भारत सरकार  
Government of India  
विद्युत मंत्रालय  
Ministry of Power  
उत्तर क्षेत्रीय विद्युत समिति  
Northern Regional Power Committee

**विषय:** संरक्षण उप-समिति की 45<sup>वीं</sup> बैठक के कार्यवृत्त।  
**Subject:** Minutes of 45<sup>th</sup> Protection Sub-Committee Meeting.

## ***Minutes of 45<sup>th</sup> Meeting of Protection Sub-committee***

# DR of 400kV Muzaffarnagar-Aataur(end)

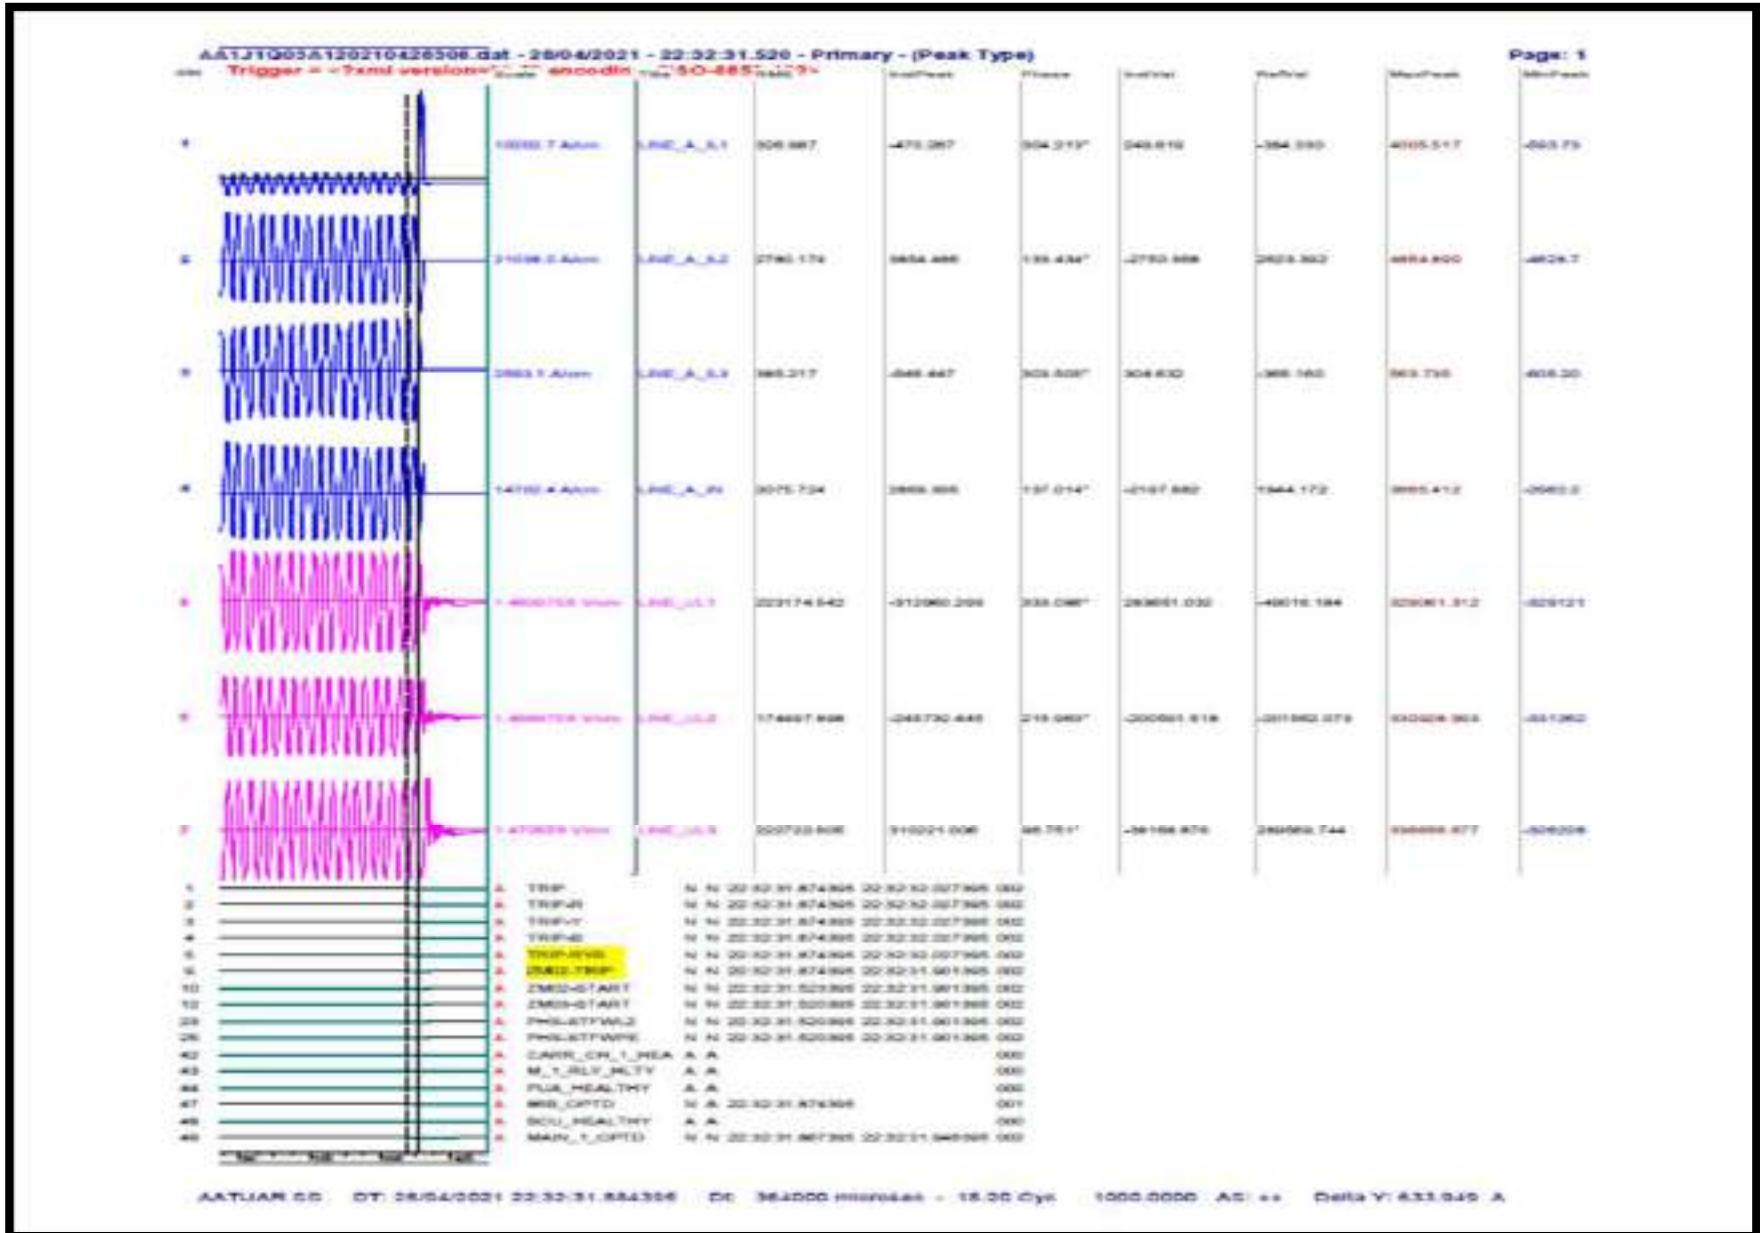
Z-2 trip within 350ms

# DR of 400kV Muzaffarnagar-Roorkee(end)

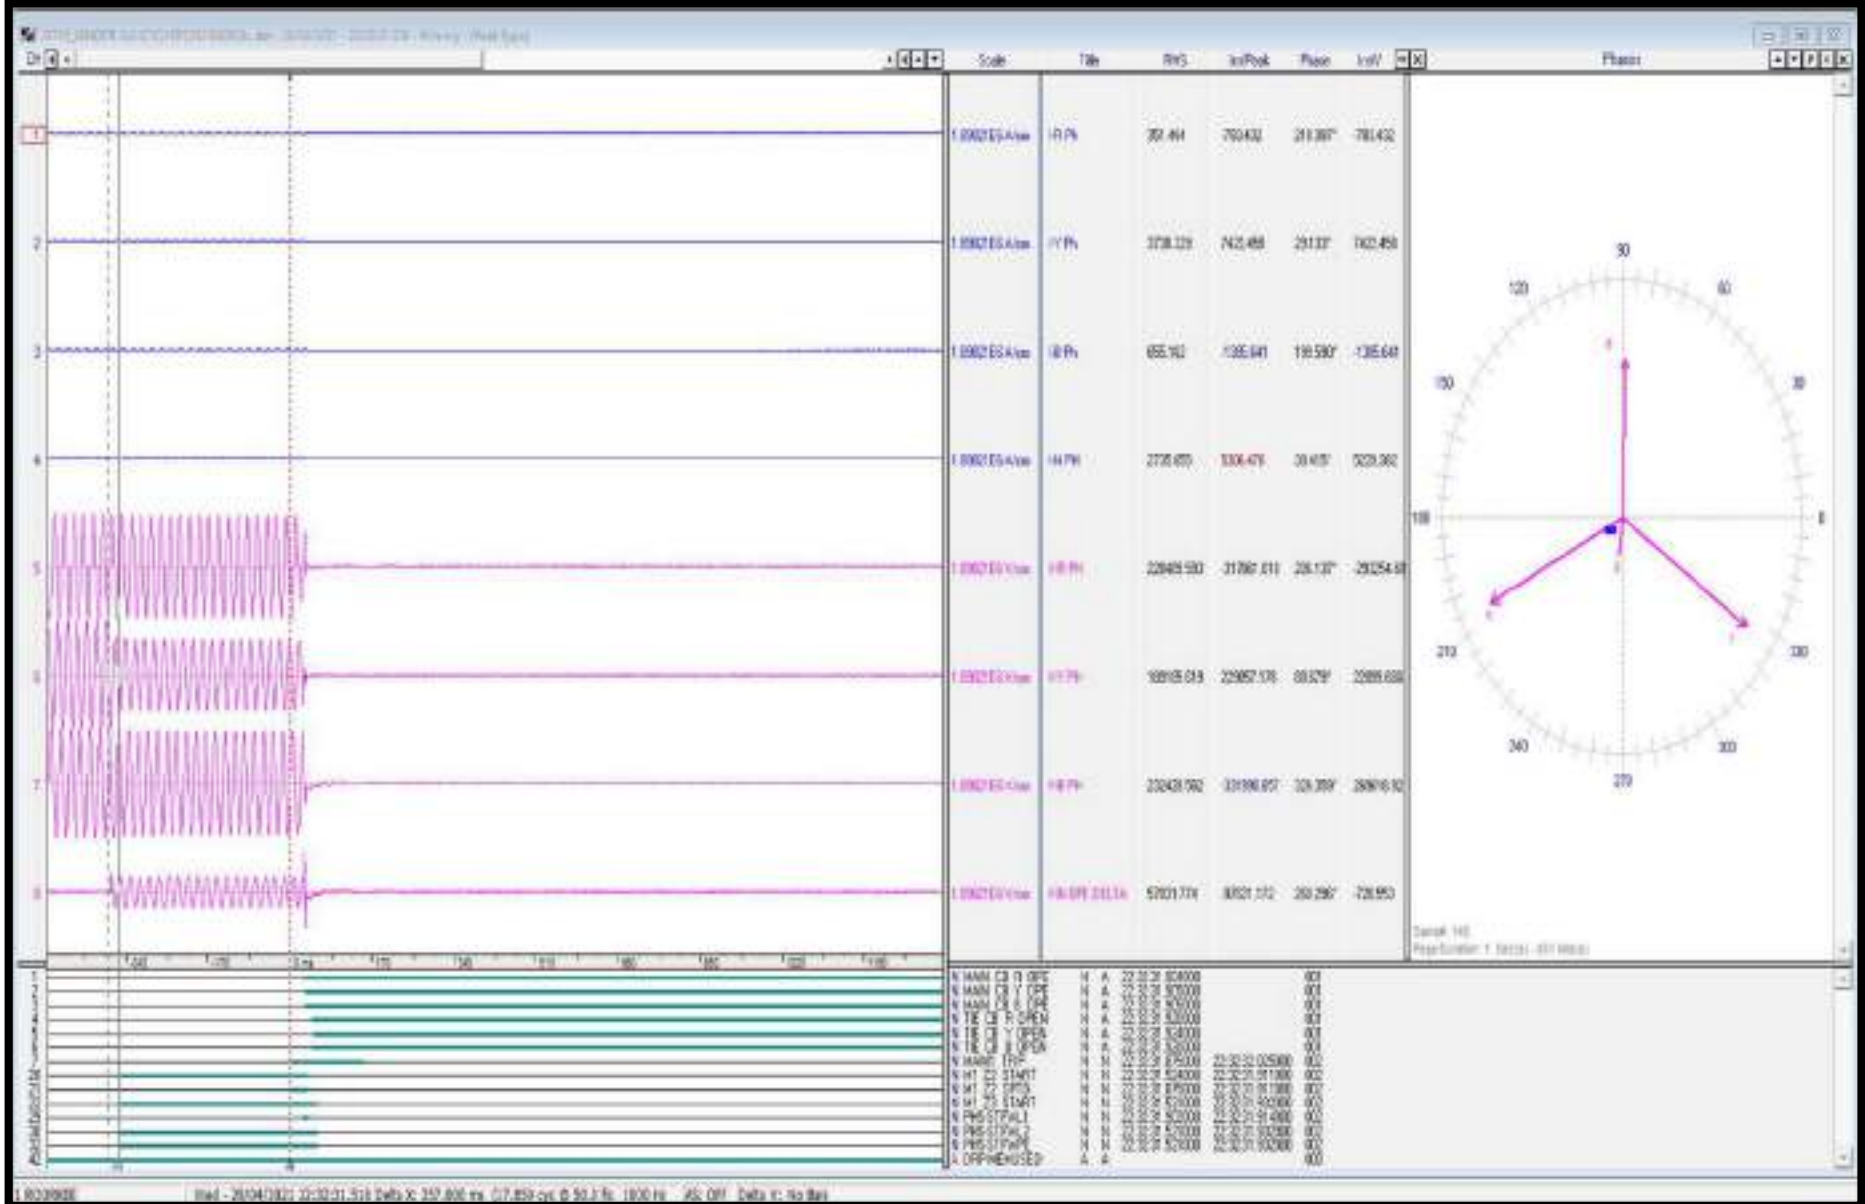
Z-2 trip within 350ms

## Points for discussion to be taken up in 45<sup>th</sup> PSC

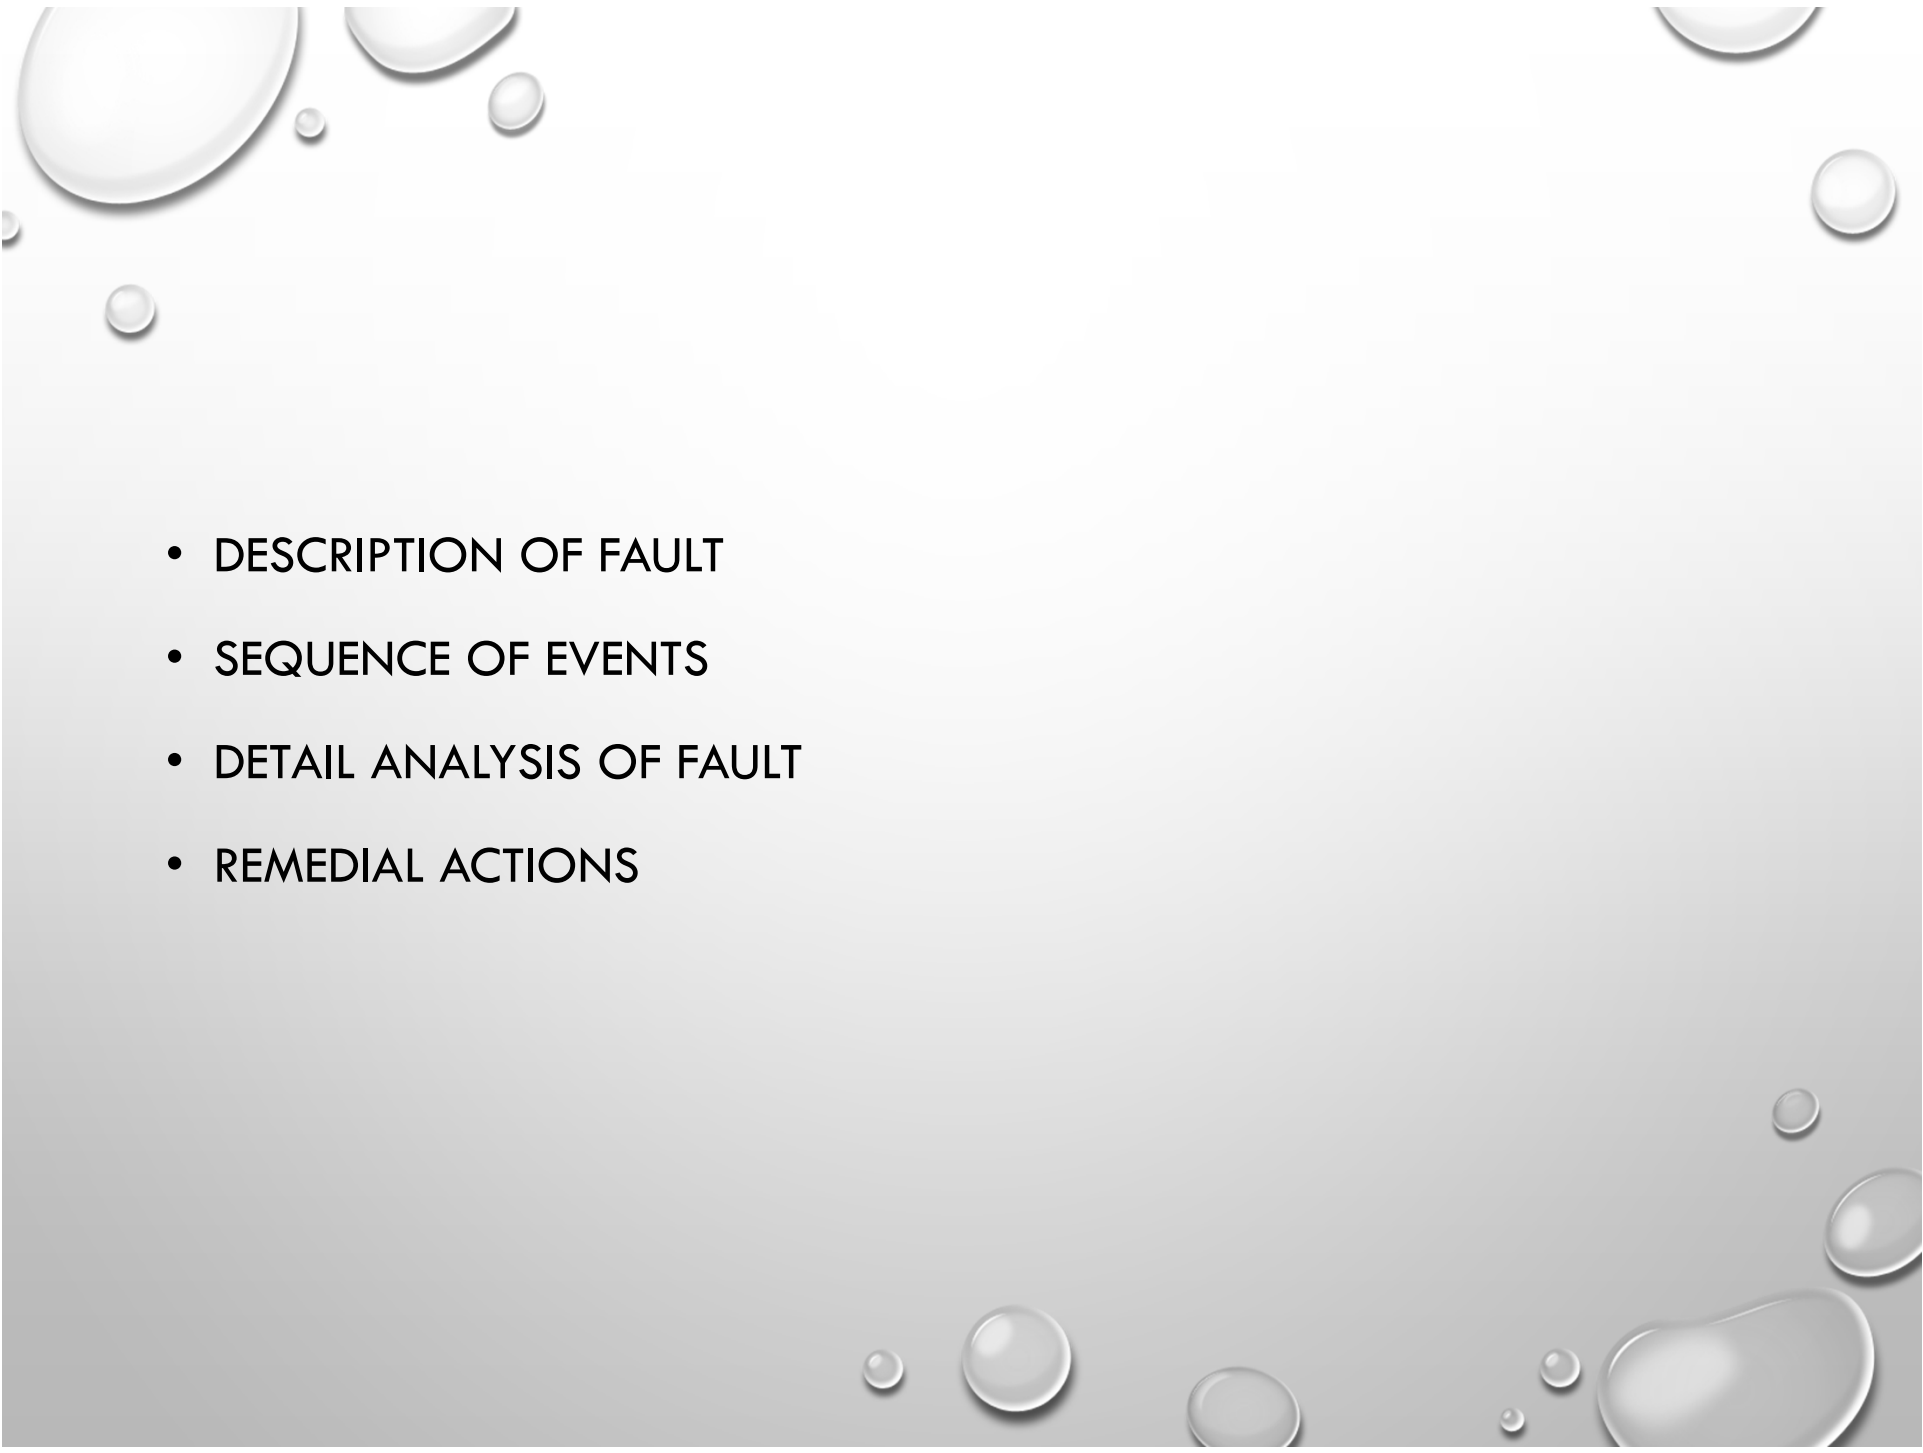
- Why 400KV Alaknanda GVK(UPC)-Vishnuprayag Ckt-I tripped?
- 400kV Vishnuprayag -Alaknanda line hand tripped from 400kV Vishnuprayag end at 22:34 hrs .
- DR of this line not submitted.
- Line was hand tripped.
- What was the exact nature and location of Fault?
- Y Phase CT blasted of 400KV Bus Coupler.
- Details of remedial measures taken to be shared.
- Damaged CT was replaced.

# Observations

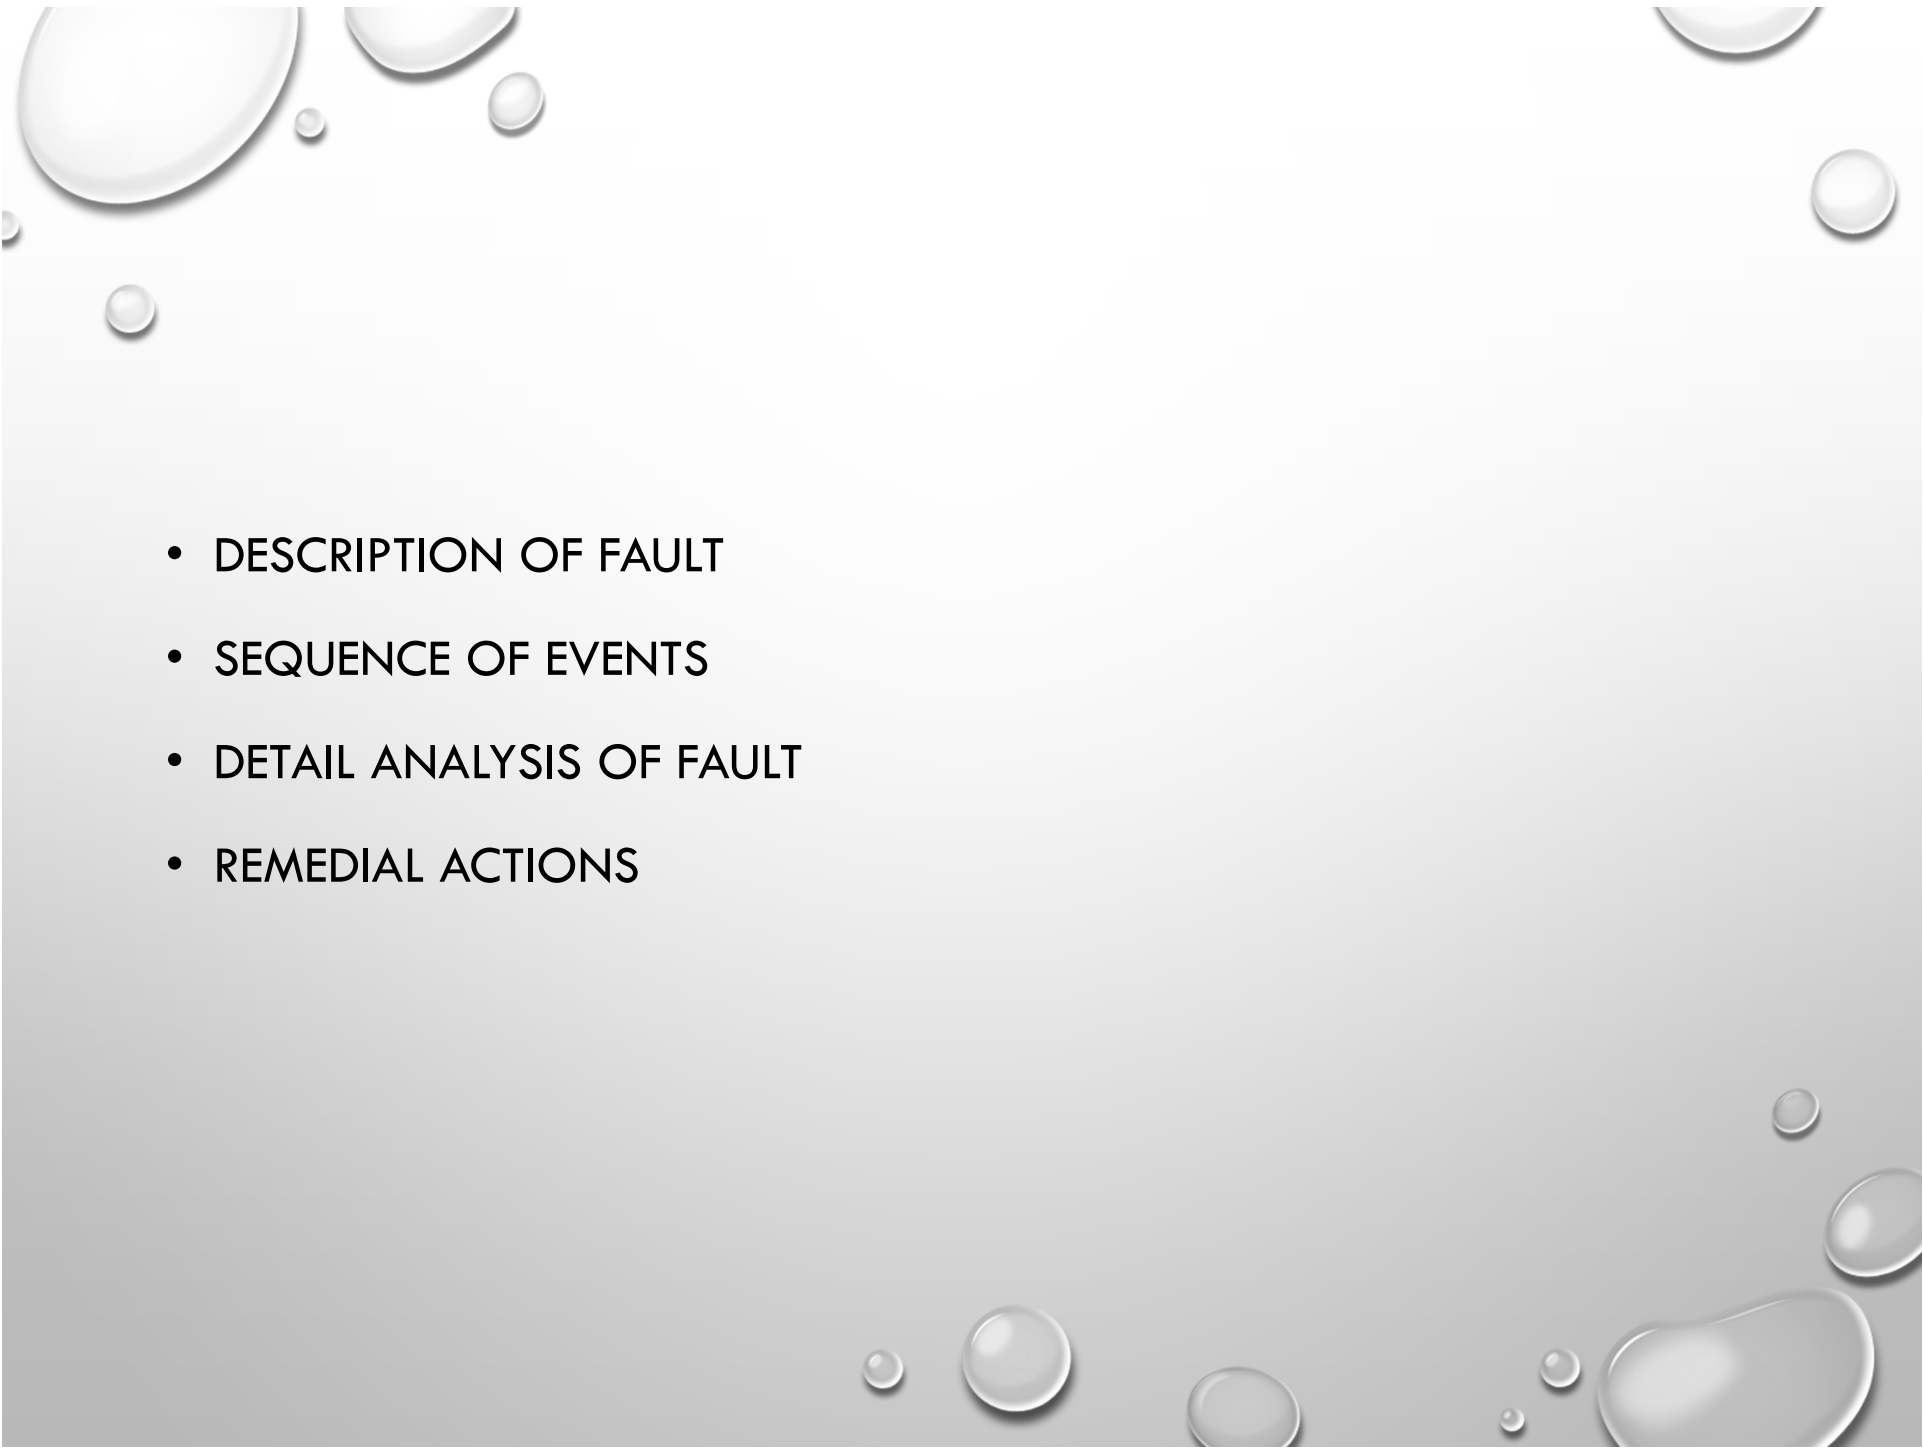
1. Reason of occurrence of fault?
2. Complete DR/EL & tripping report not uploaded on tripping portal by SLDC-UP & SLDC-UK.
3. Reason of delayed clearance of fault?
4. DR of 400kV Alaknanda (end)-Muzaffarnagar line not submitted. Whether distance Protection operated at Alaknanda end?
5. Reason for tripping of 220 KV Singoli Bhatwari(Singoli(LTUHP))-Srinagar(UK) (PTCUL) Ckts not clear?
5. Remedial action taken report needs to be shared.
6. DRs of Alaknanda and singoli units not shared.
